FILES:
OP.18.016 & Z.18.028

Re: 7028 Yonge Street and 2 Steeles Avenue West
Applications for Official Plan and Zoning By-law Amendment
By Yonge & Steeles Developments Inc. c/o The Gupta Group
File No's: OP.18.016 and Z.18.028
City of Vaughan

**Re: Proposed Official Plan Amendment
Yonge & Steeles Developments Inc. c/o Gupta Group
7028 Yonge Street and 2 Steeles Avenue West
Vaughan File Nos.: OP.18.016 & Z.18.028
York Region File Nos.: LOPA.18.V.0048 & ZBA.18.V.0146**

**Re: TTC Review of Official Plan and Zoning By-law Amendment, Files OP.18.016 & Z.18.028
7028 Yonge Street and 2 Steeles Avenue West, Vaughan, Ontario**

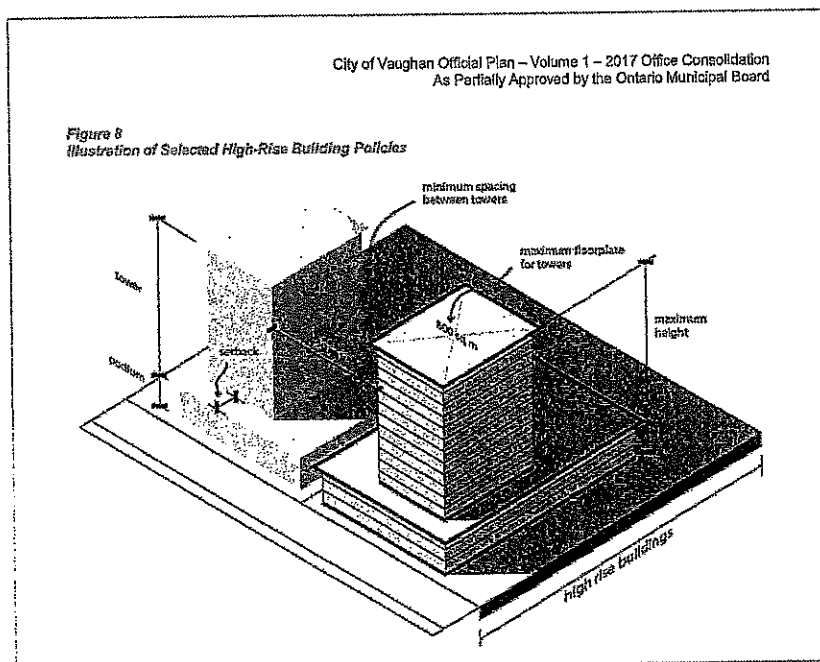
Tower 2 and Tower 3 look to be closer together than the minimum 30m. allowed by Vaughan.

Attachment 6 a)

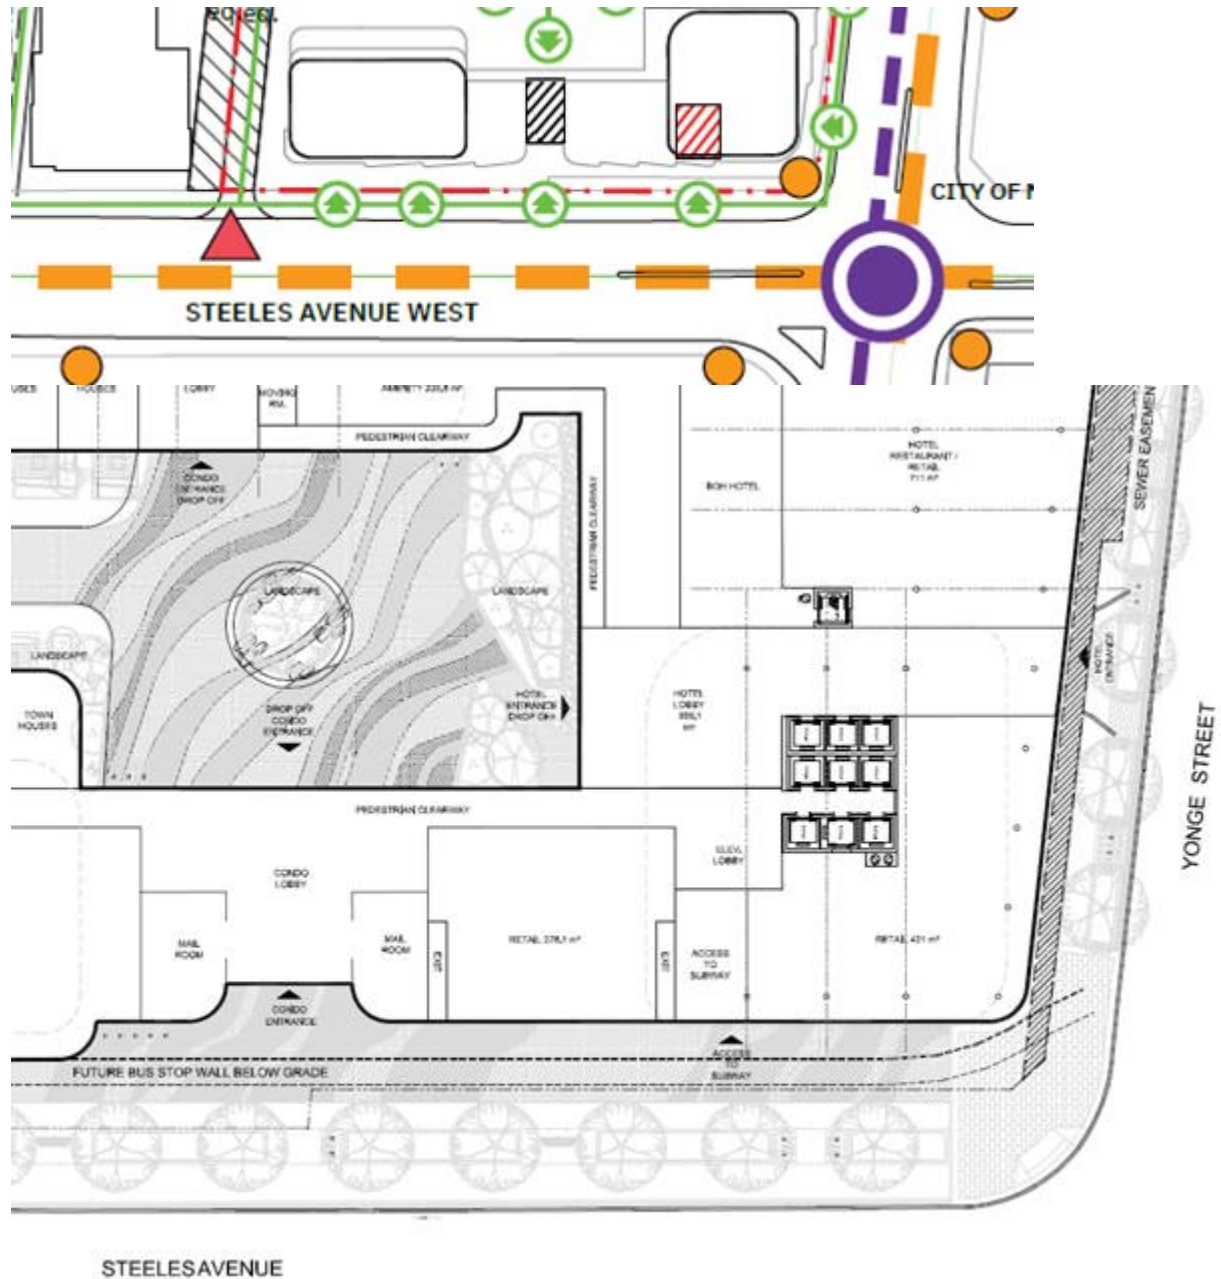
1. Developer to tie in with the proposed Steeles Subway Station, optimizing the development to incorporate or compliment the station. Please see attached the Steeles Station design from the 2012 Conceptual Design (may be subject to change).

2. On-going coordination required to determine the best location of the subway access. Steeles Station designer to recommend exit location to developer by Q1 2019. The exit location shown in the Site Plan sketch below could have implications in the passenger movement of the station.

3. Detailed road planning is required to consider the impact of the development in relation to the bus terminal west portal on Steeles Ave. It is important to confirm the developer, City of Vaughan and Toronto have considered the traffic impacts based on the future bus transit movements/volumes. The sketch below illustrates the new side street and condo access but does not show the bus portal.

5. The following conflicts with Steeles Station was noted on the developer's Site Plan Visual:
 - Developer's intake vent shaft at the location of the subway emergency exit building

- Residential towers at the location of subway entrance and ventilation infrastructure.
6. Developer to provide geo-referenced AutoCAD drawings per TTC CAD specifications in order to complete a detailed technical review.

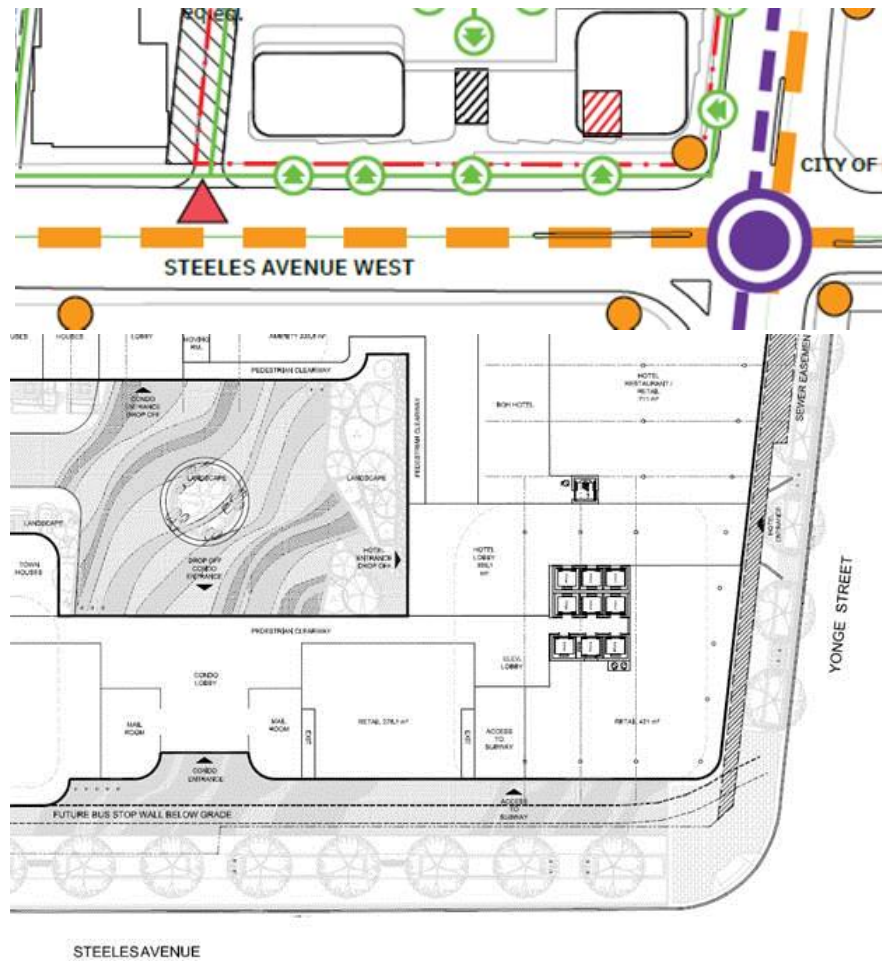
1. Developer to tie in with the proposed Steeles Subway Station, optimizing the development to incorporate or complement the station. Please see attached the Steeles Station design from the 2012 Conceptual Design (may be subject to change).

2. On-going coordination required to determine the best location of the subway access. Steeles Station designer to recommend exit location to developer by Q1 2019. The exit location shown in the Site Plan sketch below could have implications in the passenger movement of the station.

3. Detailed road planning is required to consider the impact of the development in relation to the bus terminal west portal on Steeles Ave. It is important to confirm the developer, City of Vaughan and Toronto have considered the traffic impacts based on the future bus transit movements/volumes. The sketch below illustrates the new side street and condo access but does not show the bus portal.

5. The following conflicts with Steeles Station was noted on the developer's Site Plan Visual:
 - Developer's intake vent shaft at the location of the subway emergency exit building

- Residential towers at the location of subway entrance and ventilation infrastructure.
6. Developer to provide geo-referenced AutoCAD drawings per TTC CAD specifications in order to complete a detailed technical review.

Figure 1: Appendix C (south) – Existing Property Parcels, Proposed Local Streets, Parks & Publicly Accessible Open Space, YSCSP

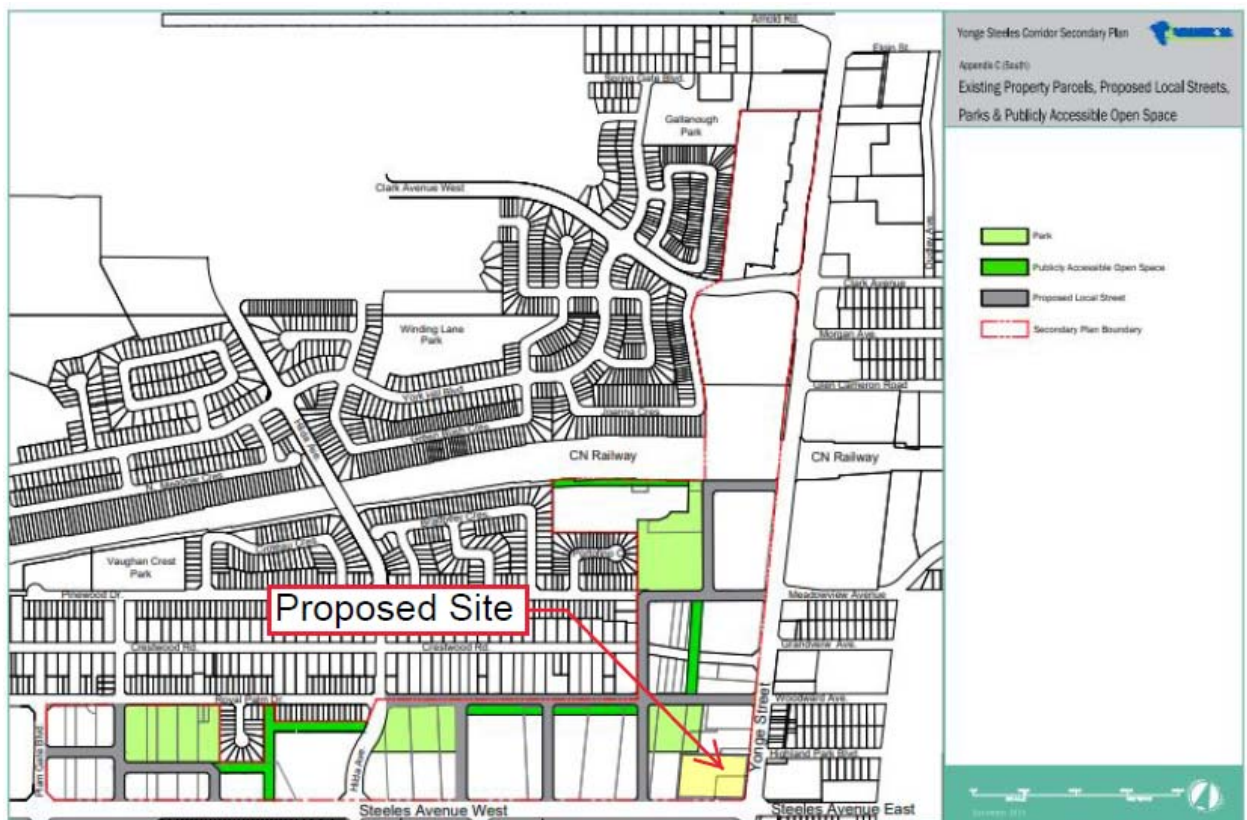
6. A Quadrant Level Study should be conducted, in coordination with adjacent landowners, to provide mutual services, infrastructure and benefits to all properties in the northwest quadrant of Yonge and Steeles intersection. See *Schedule 5 (south) – Proposed Local Streets*, YSCSP or see *Appendix C (south) – Existing Property Parcels, Proposed Local Streets, Parks & Publicly Accessible Open Space*, YSCSP.

The Quadrant Study can evaluate, amongst other needs, a connected, coordinated, porous laneway network providing better interconnectivity within the quadrant and better
